2023 SEA LEVEL RISE AND FLOOD RESILIENCY PLAN

DRAFT JUNE 2023

Public Comments

(Comment Period: May 24, 2023 - June 30, 2023)

Figure 9. Adaptation Pathways map for the entire basin, based on the simulated expected annual damage for the current sea-level and the two possible future sea level rise scenarios.

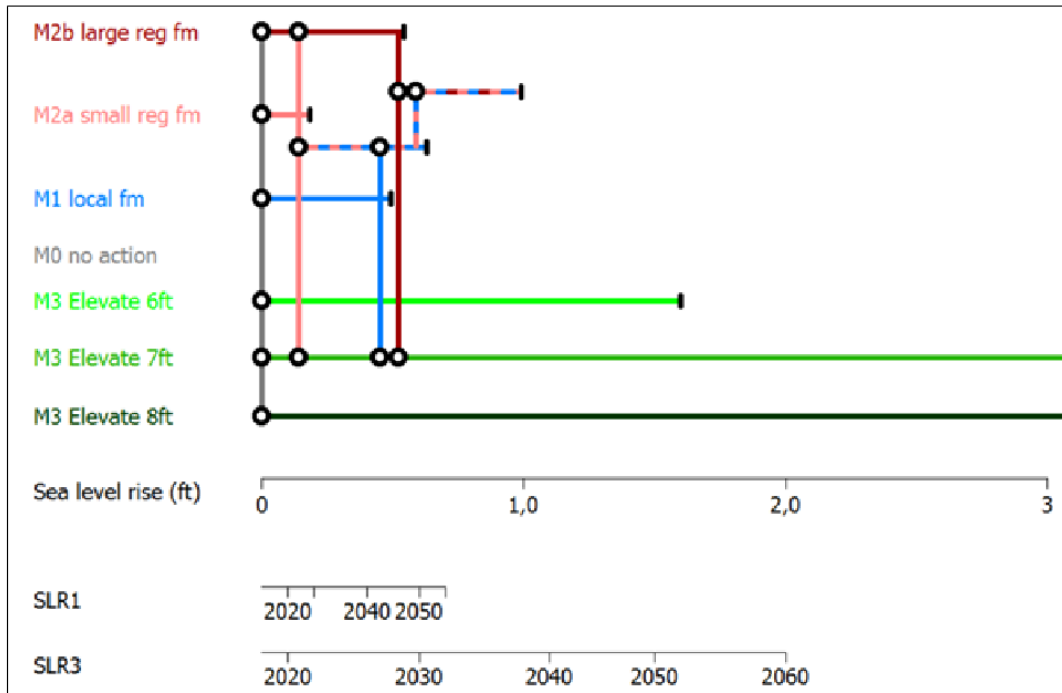
The partnership will be essential to address the larger regional adaptation needs to ensure that multiple flood protection measures are advanced. The excellent work by your agency has shown that expanding pump capacity on the primary canals may be necessary but may not be sufficient to address sea level rise, particularly for coastal areas. In some instances, it may be more effective, enduring, and cost-effective to elevate or floodproof properties. As shown in the C-7 Level of Service assessment, in some instances non-structural flood mitigation measures, such as raising the lowest-lying properties (shown in green below), may have substantially longer efficacy than forward pumps.

The SFWMD has determined that a gravity-driven system may not be able to continue indefinitely, MDC requests that the District fully consider and implement other flood mitigation and water quality programs in advance of moving toward an extensive forward pumping approach. As the SFWMD's draft plan states, projects that "slow the flow" including retention, infiltration, and evaporation/evapotranspiration to reduce runoff should be prioritized and MDC is committed to working together with SFWMD to find opportunities to fulfill these goals. Other measures such as optimizing operations, non-structural flood mitigation, increasing basin interconnectivity, distributed storage, emergency detention basins, raising canal banks, canal dredging, and nature-based solutions could be pursued aggressively in the short term ahead of deployment of multiple forward pumps. We also encourage further exploration and consideration of potential strategies like voluntary home buyouts for the most vulnerable areas which could be paired with environmental restoration, creation and expansion of water storage areas and other nature-based features to help restore more natural floodplain functions and reduce reliability on mechanical pumping systems. In many instances, this type of approach will require coordination with other entities to implement flood mitigation measures that are outside the District's purview, and MDC stands ready as a dedicated partner to pursue those projects. Regardless of potentially selected options, final plans should not negatively impact important natural areas including Miami-Dade County's Environmentally Endangered Lands (EEL) and SFWMD could work with the County in acquiring and managing EEL parcels and other key parcels adjacent to canals to support efforts to "slow the flow" as priority projects of note in the SFWMD's tentative 2023 plan. Additionally, MDC recognizes SFWMD's commitment to partner on resiliency efforts at the S-27 and other structures, consistent with the recommendations of the Biscayne Bay Task Force and SFWMD's own commitment to Biscayne Bay health through the development and implementation of its Surface Water Improvement and Management (SWIM) Plan. The SWIM Act's express concern was that "... the declining quality of the state's surface waters has been detrimental to the public's right to enjoy these surface waters and it is the duty of the state, through the state's public agencies and subdivisions, to enhance the environmental and scenic value of surface waters." Contributing factors listed for the decline are the input of point and non-point sources of pollution and the destructions of natural systems." SFWMD has a responsibility to ensure that its actions are consistent with any applicable surface water standards and do not further degrade water quality received by the state's Outstanding Florida Waters downstream.
